CRMC DECISION WORKSHEET

2022-06-127

4772 Old Post Road, LLC

STATE OF RHODE ISLAND
COASTAL RESOURCES MANAGEMENT COUNCIL
STAFF REPORT TO THE COUNCIL

Figures 1 & 2. Location of possible additional wetlands

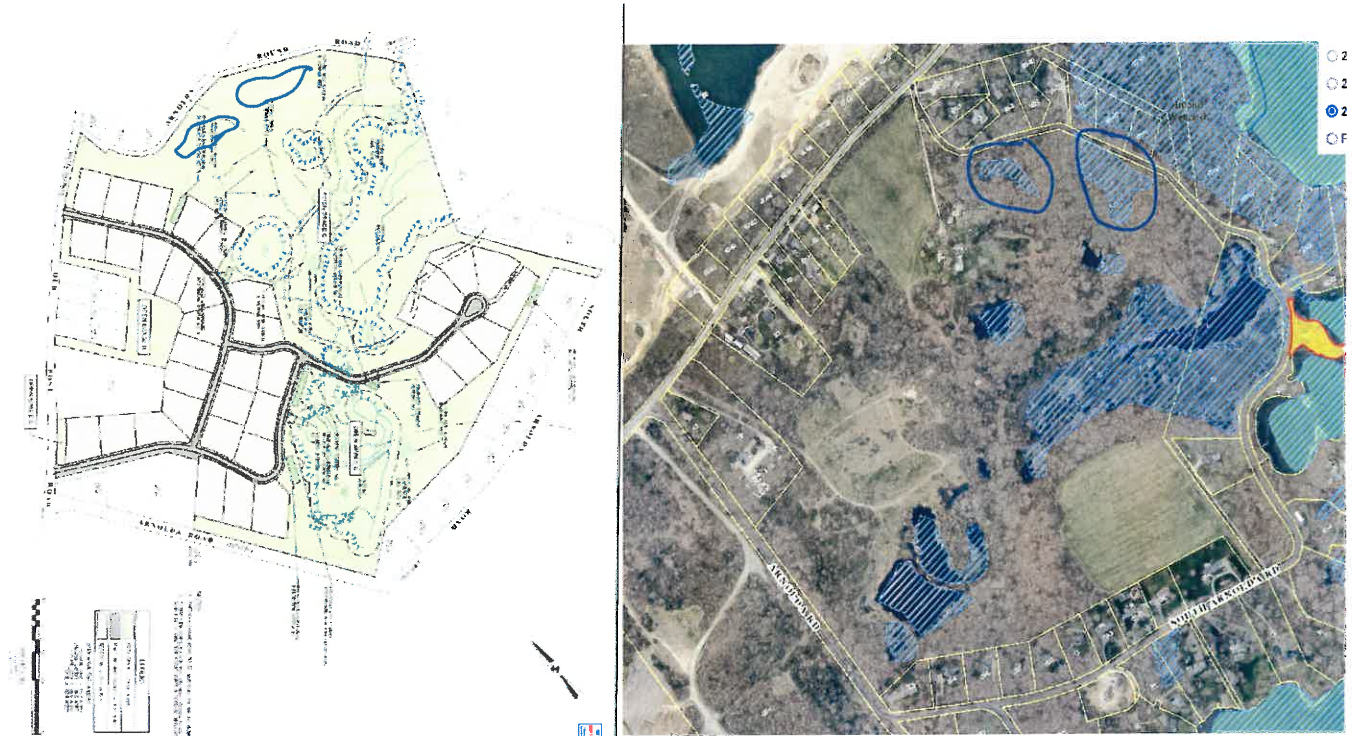
edges delineated and shown by you on-site and on site plans submitted with your application and as qualified in this letter. Should you wish to verify the edge of any additional wetlands, an additional application will be required.” Review of aerial photography and soils show that there are likely additional wetlands located in the northern portion of the property, along Arnolda Round Rd, and appear to fall entirely within an area designated as “open space C” (Ref Figures 1 & 2).
